MORGAN AND MORECAMBE OFFSHORE WIND FARMS: TRANSMISSION ASSETS

Change Request Outline Highway Access Management Plan (Tracked)

Deadline: Deadline 4
8 August 2025

MOR001-FLO-CON-ENV-PLN-0059
MRCNS-J3303-RPS-10076

TITLE
ACCESS A7
CHANGE REQUEST
GENERAL ARRANGEMENT

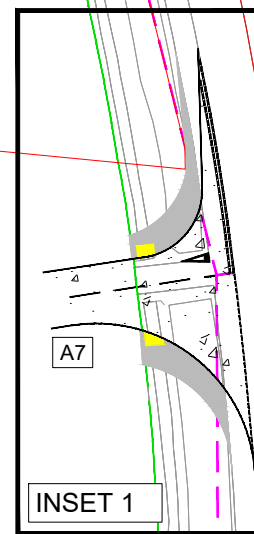
- Minor corrections to drafting noted by the Applicants;
- Minor revisions to the locations of access A63 presented in **Appendix A**;
- Minor revisions to the locations of accesses A7/A9, A9 and the addition of access A9b as a result of the proposed Change Request;

| Access ID | Road name | Access type | Posted Speed Limit (PSL) or measured 85 th percentile speed (mph) | Required visibility splay distance for the PSL or measured speed (*), **, *** | Drawing number | Notes |
|-----------|------------------------------|---|--|---|---|---|
| A7 & A8 | B5261 | New Access | 40 (PSL) | 120m | PC1165-RHD-ZZ-XX-SW-TP-0004 & 00520161, 0162, 0163 & 0164 | N/A |
